VALUE ENGINEERING REPORT

SR 20 Widening
Forsyth and Gwinnett Counties
STP-0002-00(392); PI No.: 0002392
BRST-054-1(63); PI No.: 132985
MLS-000-00(430); PI No.: 0004430

December 18, 2007

ITEM N^o: A-2.1
 CLIENT: GDOT
 Sheet 2 of 4

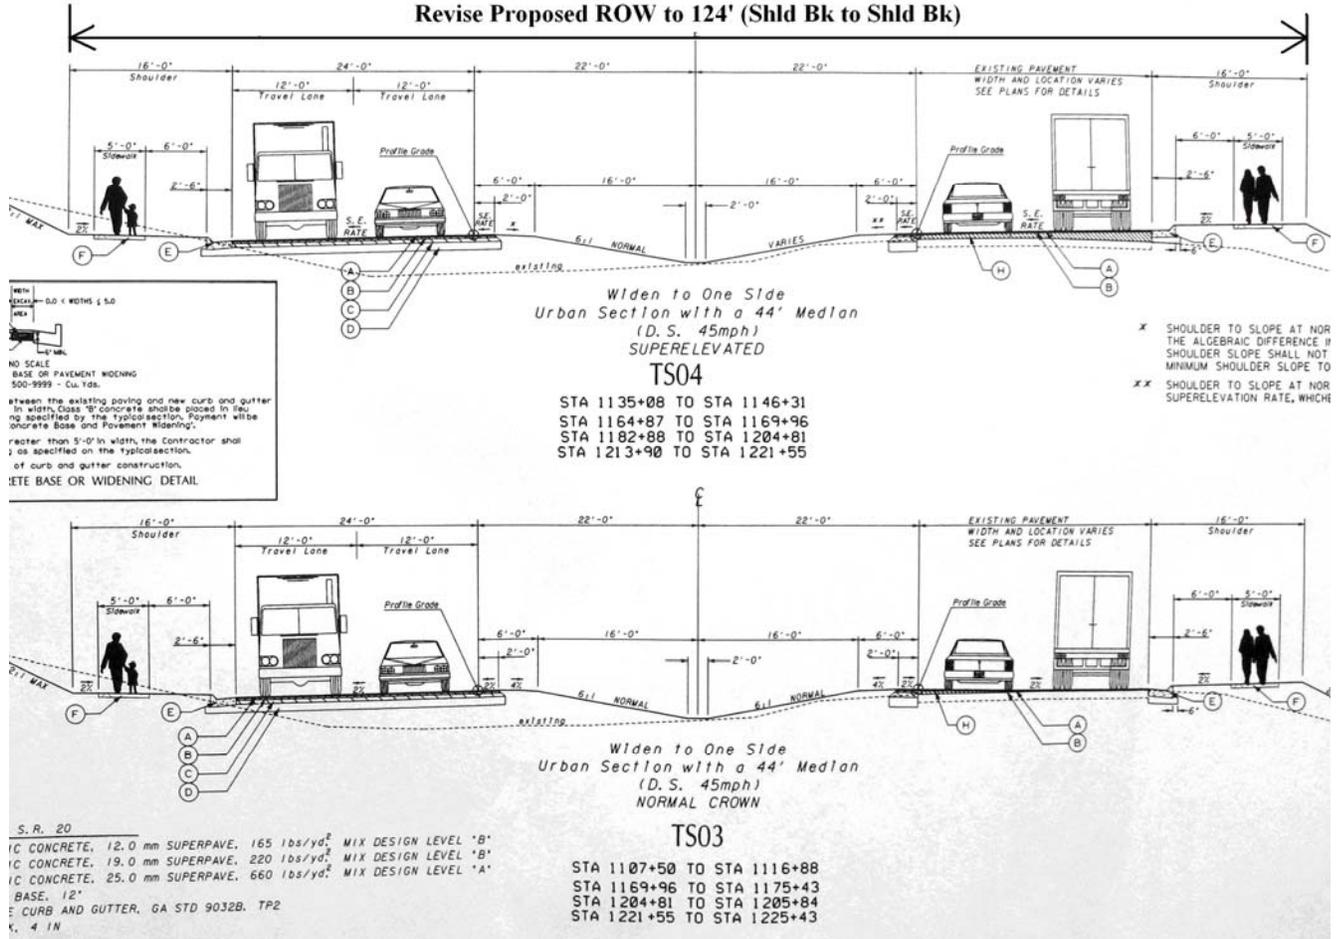
Proposed Change:

Revise the proposed right-of-way width to include only the area in between the two outside shoulder breakpoints (124') and use easements for the remaining 16 feet.

The change from right-of-way to easement will not impede the function of the project and will result in significant cost savings.

ITEM N^o: A-2.2
 CLIENT: GDOT
 Sheet 2 of 4

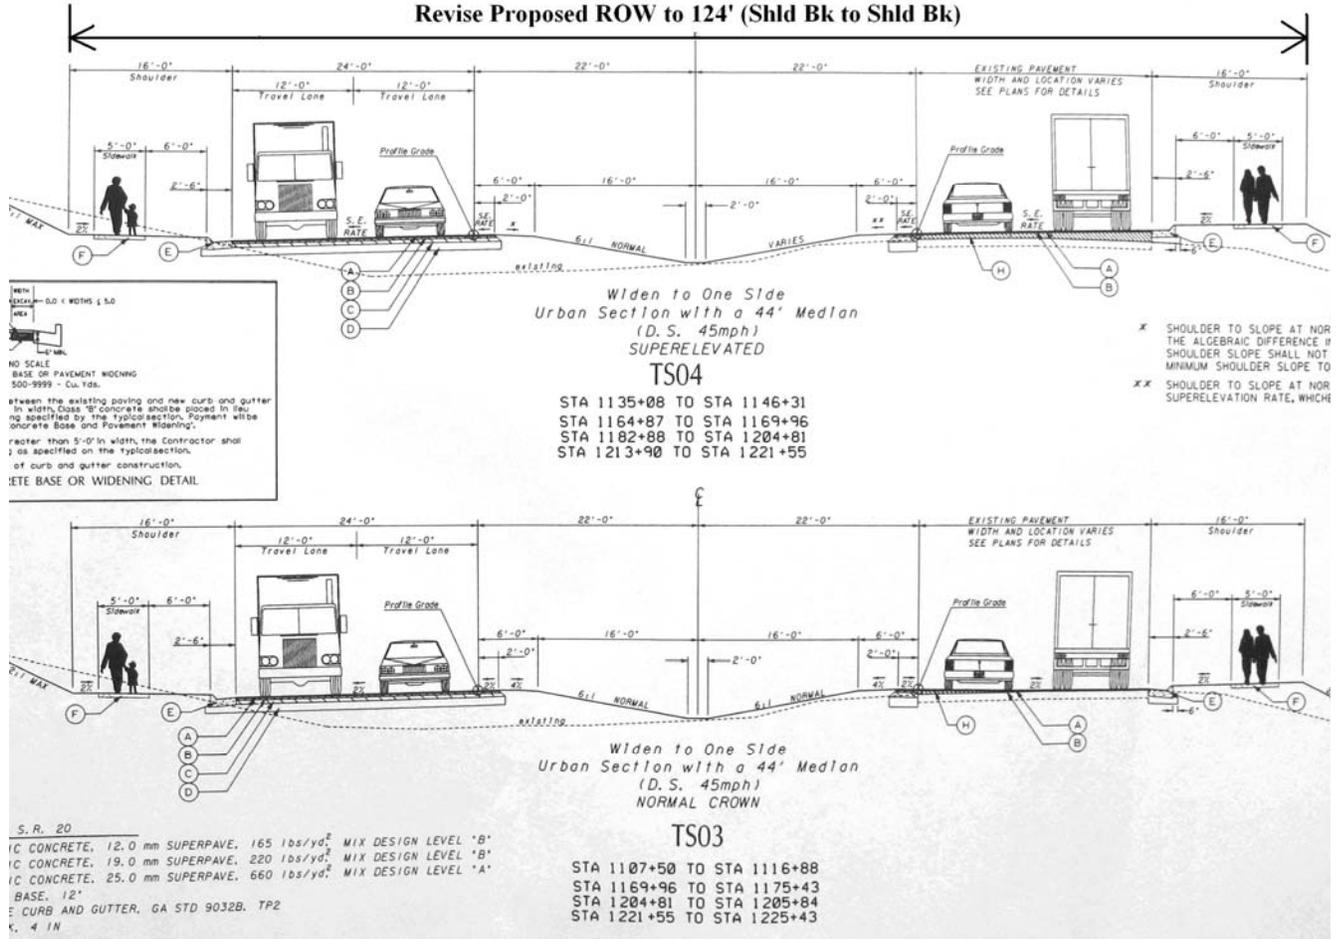
Proposed Change:

Revise the proposed right-of-way width to include only the area in between the two outside shoulder breakpoints (124') and use easements for the remaining 16 feet.

The change from right-of-way to easement will not impede the function of the project and will result in significant cost savings.

ITEM N^o: A-2.3
 CLIENT: GDOT
 Sheet 2 of 4

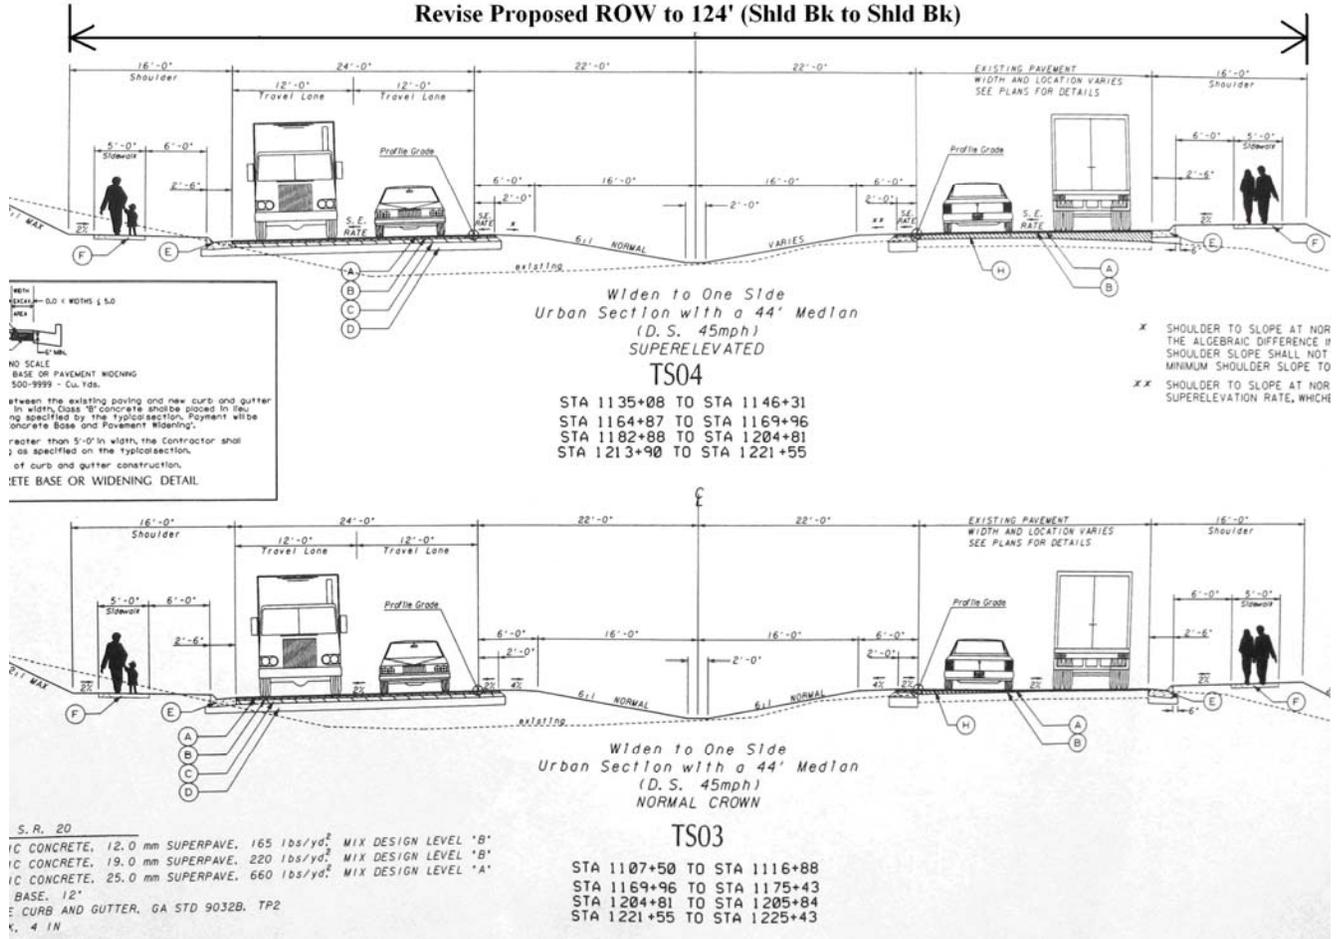
Proposed Change:

Revise the proposed right-of-way width to include only the area in between the two outside shoulder breakpoints (124') and use easements for the remaining 26 feet.

The change from right-of-way to easement will not impede the function of the project and will result in significant cost savings.

ITEM N^o: A-4.1
CLIENT: GDOT
Sheet 2 of 4

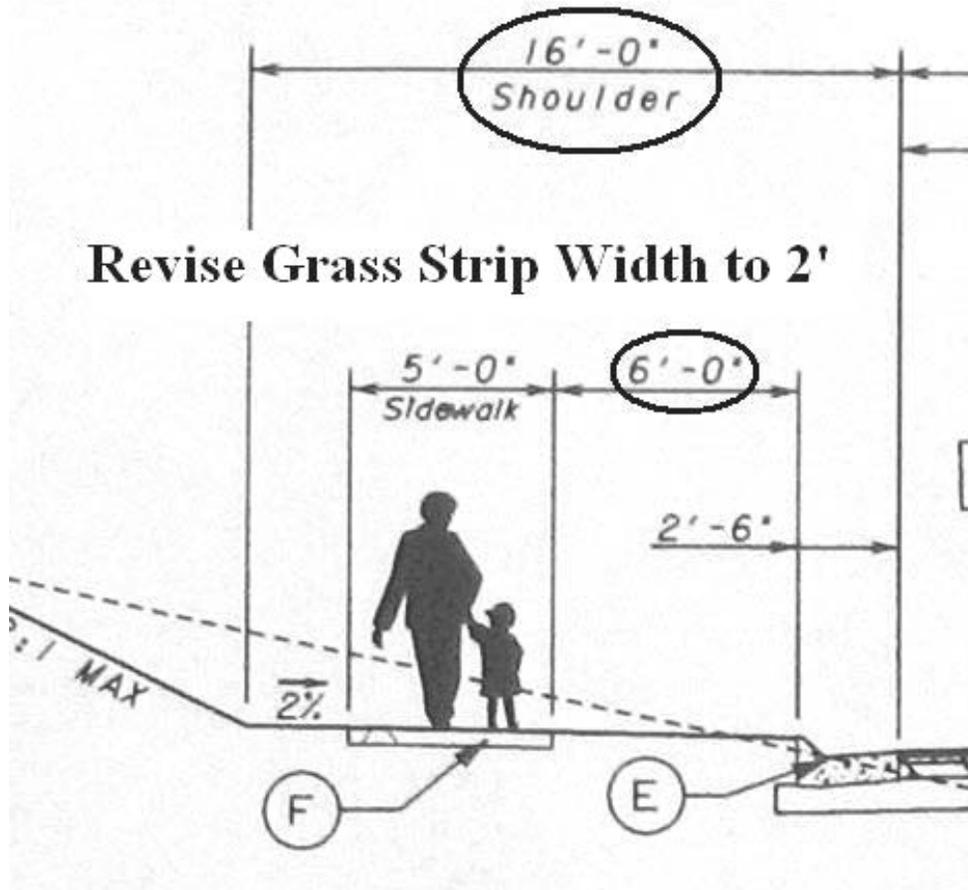
Proposed Change:

Revise the typical section for SR 20 to include 12' outside urban shoulder (30" curb & gutter, 2' grass strip, 5' sidewalk) on both sides of the road.

Revise Shoulder Width to 12'

Revise Grass Strip Width to 2'

ITEM N^o: A-4.2
CLIENT: GDOT
Sheet 2 of 4

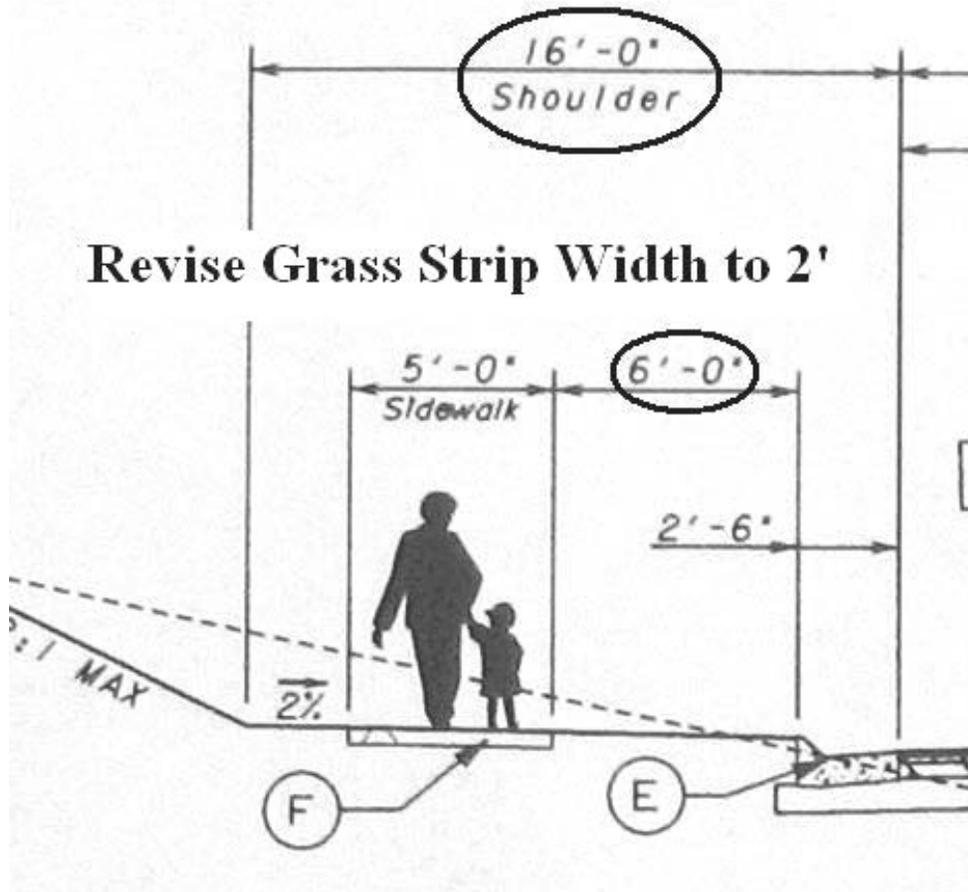
Proposed Change:

Revise the typical section for SR 20 to include 12' outside urban shoulder (30" curb & gutter, 2' grass strip, 5' sidewalk) on both sides of the road.

Revise Shoulder Width to 12'

Revise Grass Strip Width to 2'

ITEM N^o: A-4.3
CLIENT: GDOT
Sheet 2 of 4

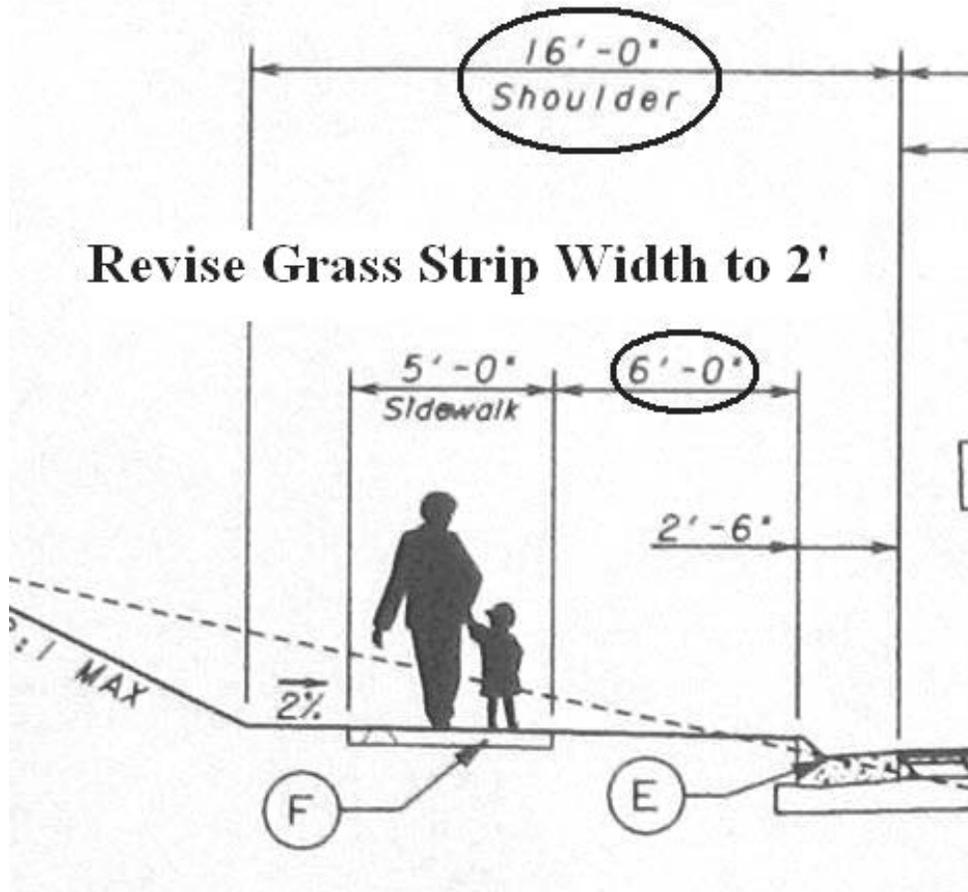
Proposed Change:

Revise the typical section for SR 20 to include 12' outside urban shoulder (30" curb & gutter, 2' grass strip, 5' sidewalk) on both sides of the road.

Revise Shoulder Width to 12'

Revise Grass Strip Width to 2'

ITEM N^o: B1.1
 CLIENT: GDOT
 Sheet 2 of 4

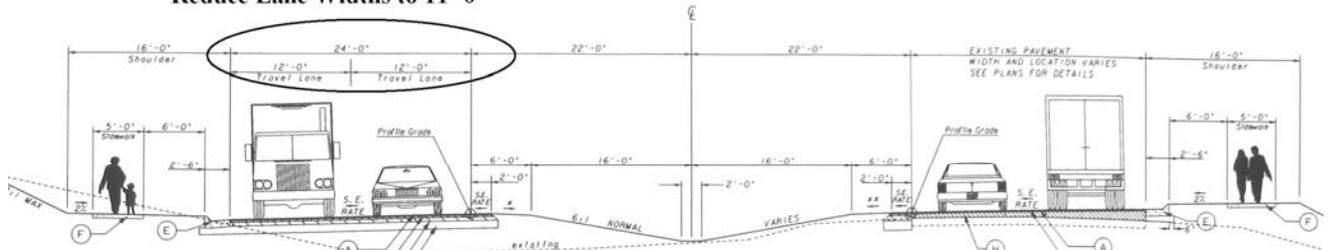
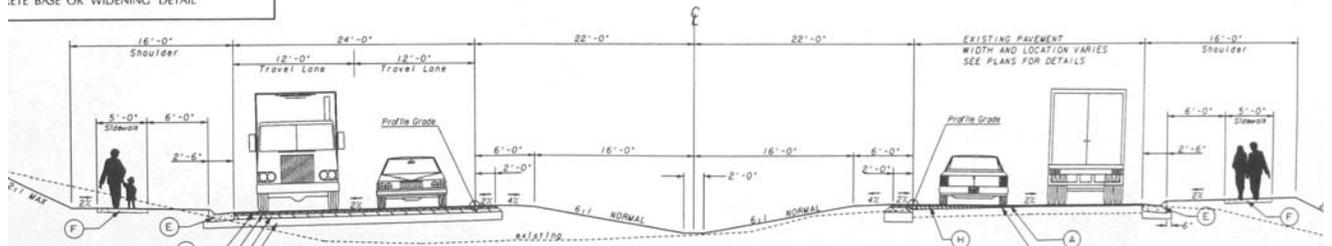
Proposed Change:

Revise the typical section for SR 20 to utilize 2 – 11 foot travel lanes for the widening section.

Reduce Lane Widths to 11'-0"

The reduction in lane widths will not impede the function of the project and will provide significant cost savings in right-of-way and pavement quantities.

ITEM N^o: B-1.2
CLIENT: GDOT
Sheet 2 of 4

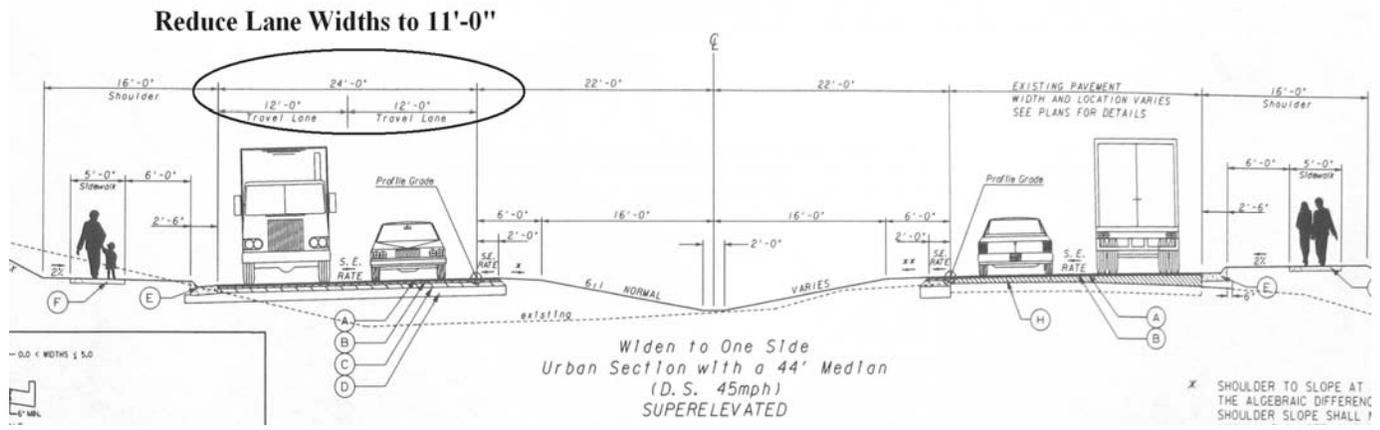
Proposed Change:

Revise the typical section for SR 20 to utilize 2 – 11 foot travel lanes for the widening section.

The reduction in lane widths will not impede the function of the project and will provide significant cost savings in right-of-way and pavement quantities.

ITEM N^o: B1.3
 CLIENT: GDOT
 Sheet 2 of 4

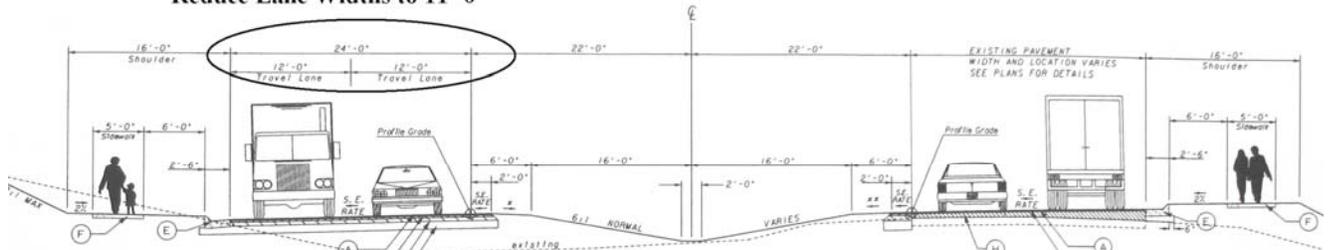
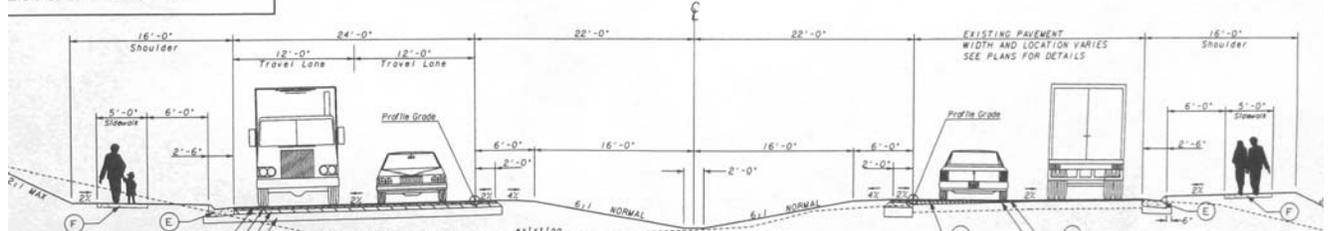
Proposed Change:

Revise the typical section for SR 20 to utilize 2 – 11 foot travel lanes for the widening section.

Reduce Lane Widths to 11'-0"

The reduction in lane widths will not impede the function of the project and will provide significant cost savings in right-of-way and pavement quantities.

ITEM N^o: B-2.1
CLIENT: GDOT
Sheet 2 of 4

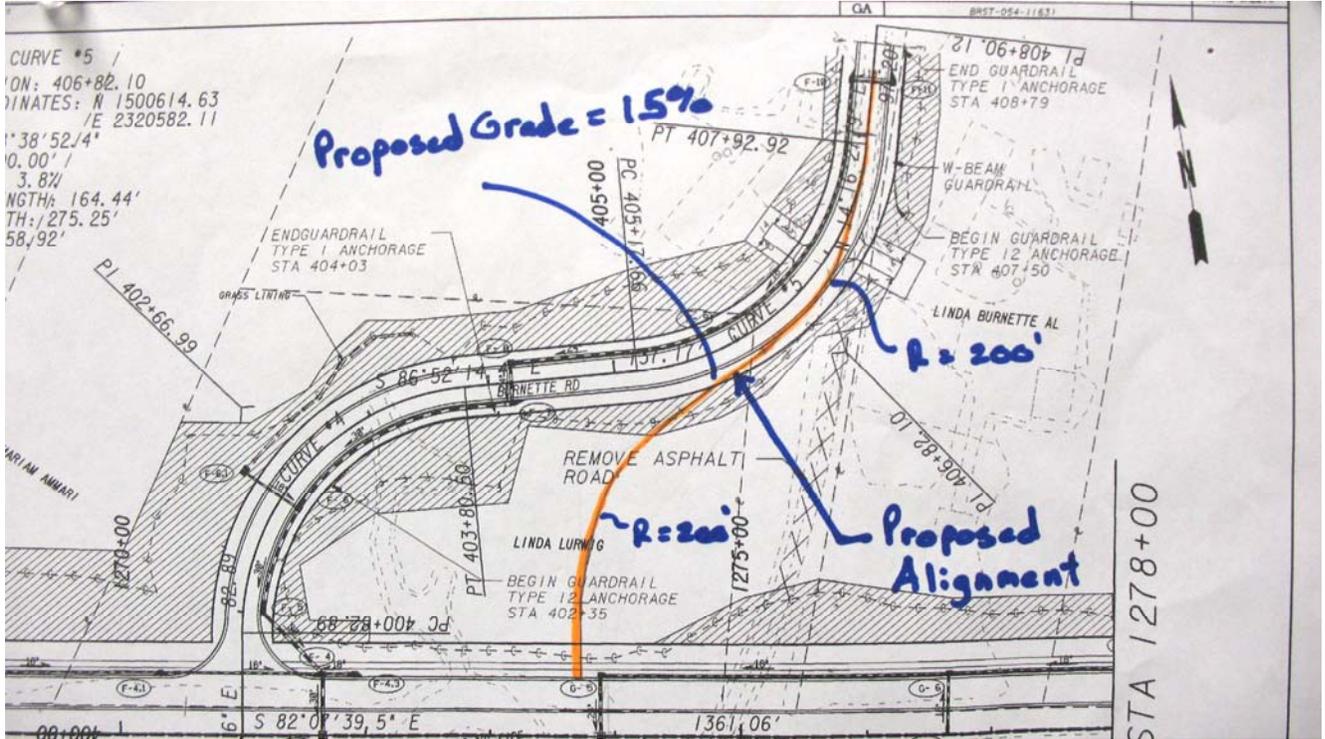
The current plans show realignment of Burnette Road for a total length of approximately 830 feet.

Proposed Change:

Revise the realignment of Burnette Road to a total length of approximately 580 feet.

The current plans show a realignment of the Burnette Trail due to the steep existing grade (18%) at the tie into SR 20. The proposed profile reduces the maximum grade to 11.3%. The GDOT Design Manual allows for a maximum vertical grade of 15% for a design speed of 25mph in mountainous terrain. The proposed change modifies the maximum grade to 15% to reduce the alignment length and provide savings in right-of-way, pavement and drainage quantities.
